ATTACHMENT C

PROPOSED TECHNICAL SPECIFICATION 3/4.7.6

SAN ONOFRE NUCLEAR GENERATING STATION

DESCRIPTION OF PROPOSED CHANGE NPF 15-163 AND SAFETY ANALYSIS

Figure 3.1-1

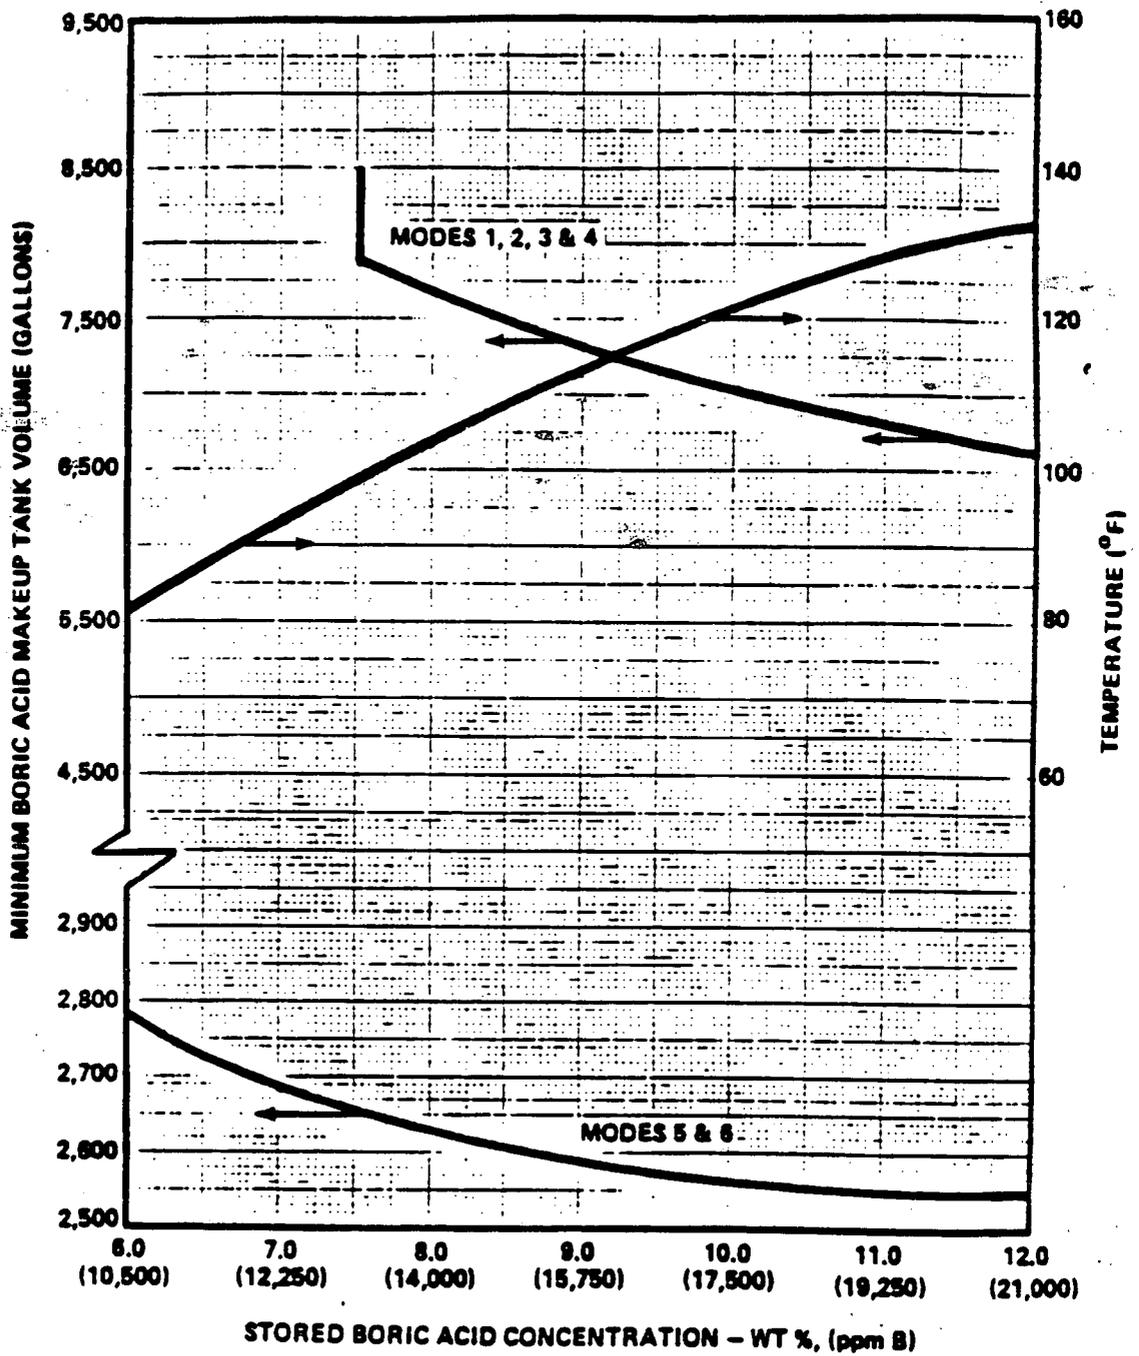
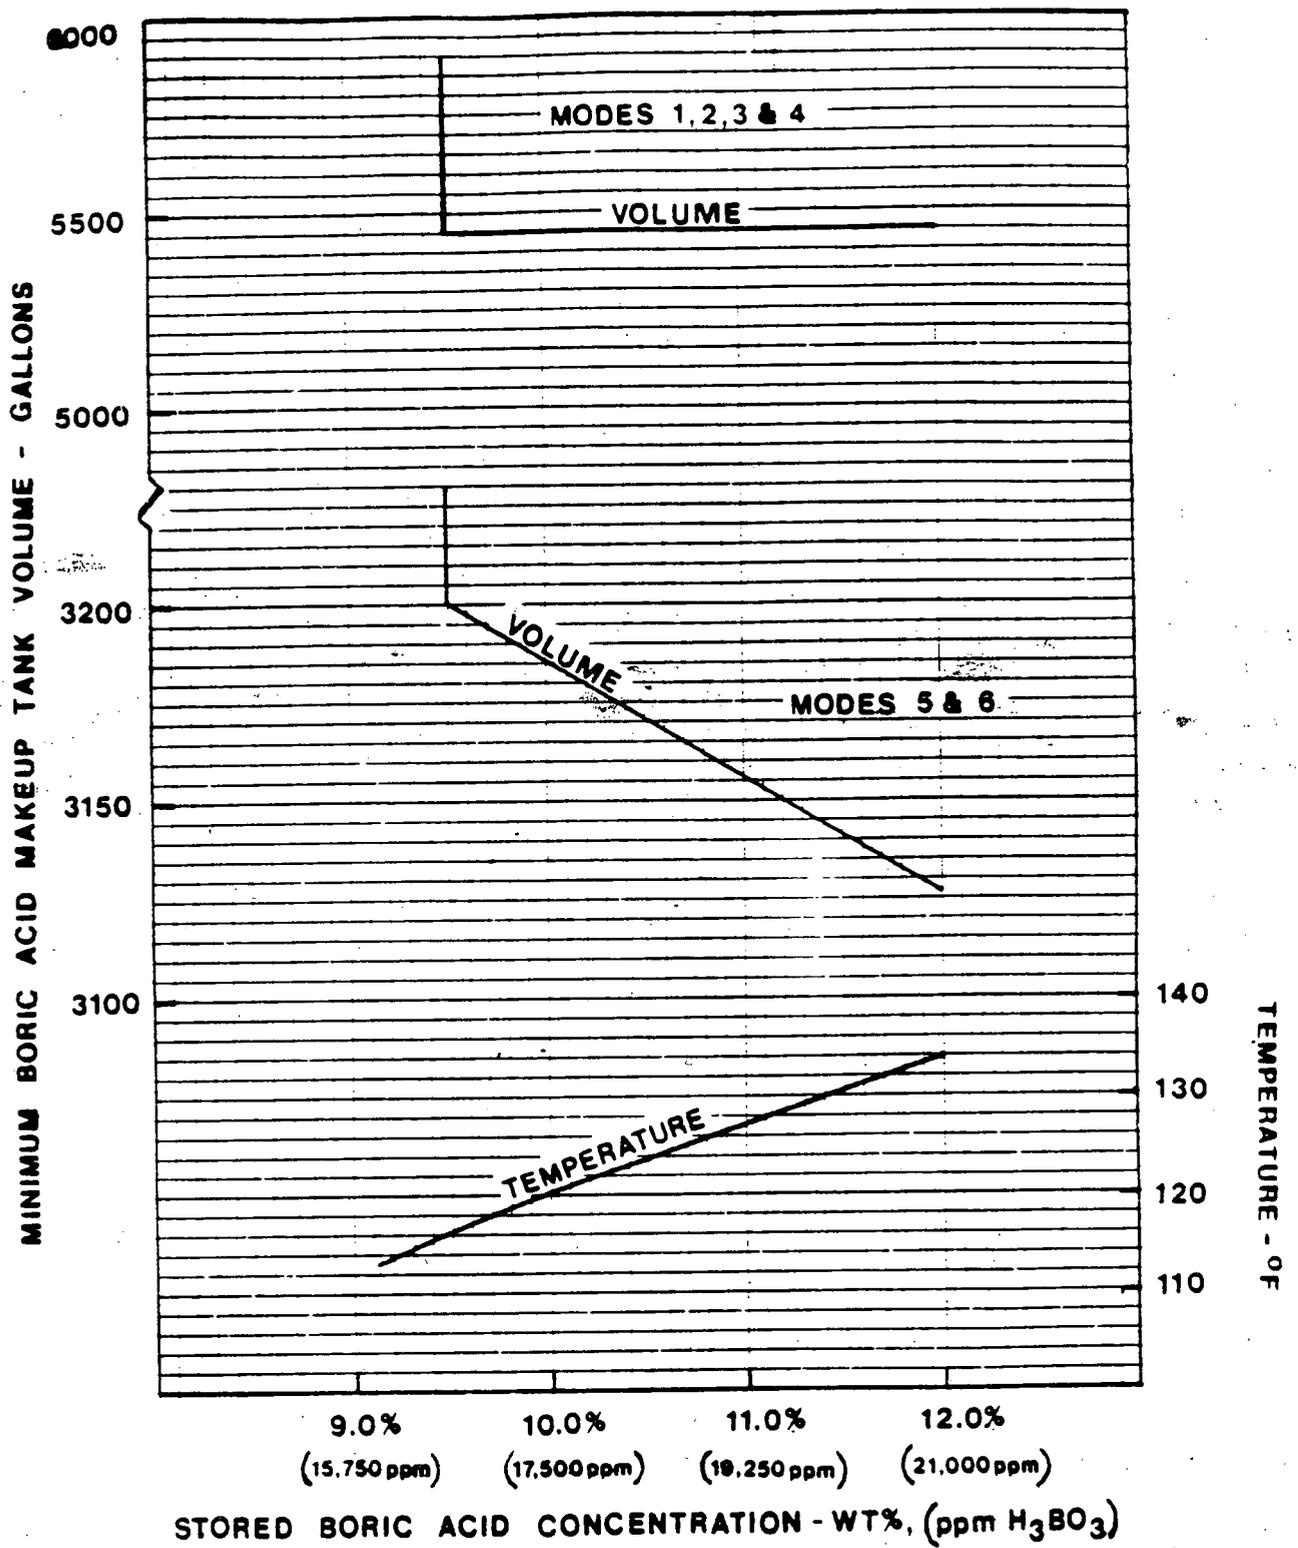
Sections 3.1.2.8 and B3/4.1.2 have been revised to specify the BAMUT volume/concentration and the RWST volume required for negative reactivity control consistent with the requirements of Cycle 2 operation. The minimum RWST volume for boration specified in Bases Section 3/4.1.2, is set by boration and makeup requirements with letdown available and BAMUT's unavailable. This volume (which has increased from 53,500 gallons for Cycle 1 to 81,970 gallons for Cycle 2, in Modes 1 through 4) exceeds that required for RCS cooldown makeup alone and remains bounded by the Safety Injection requirements of Technical Specification 3/4.5.4. The BAMUT volume/concentration required by Technical Specification 3.1.2.7 for operation in Modes 5 and 6, as shown in Figure 3.1-1, has increased for Cycle 2 in order to meet the increased Cycle 2 shutdown margin requirements. Accordingly, the minimum RWST volume for boration in Modes 5 and 6 with letdown available and BAMUT's unavailable has increased from 5465 gallons for Cycle 1 to 9970 gallons for Cycle 2.

The maximum allowed boric acid concentration specified in figure 3.1-1 remains unchanged for Cycle 2. Therefore, the boron mixing demonstrated during the preoperational natural circulation test remains valid.

MINIMUM BORIC ACID STORAGE TANK VOLUME AND MINIMUM TEMPERATURE BEFORE PRECIPITATION AS A FUNCTION OF STORED BORIC ACID H₃BO₃ CONCENTRATION
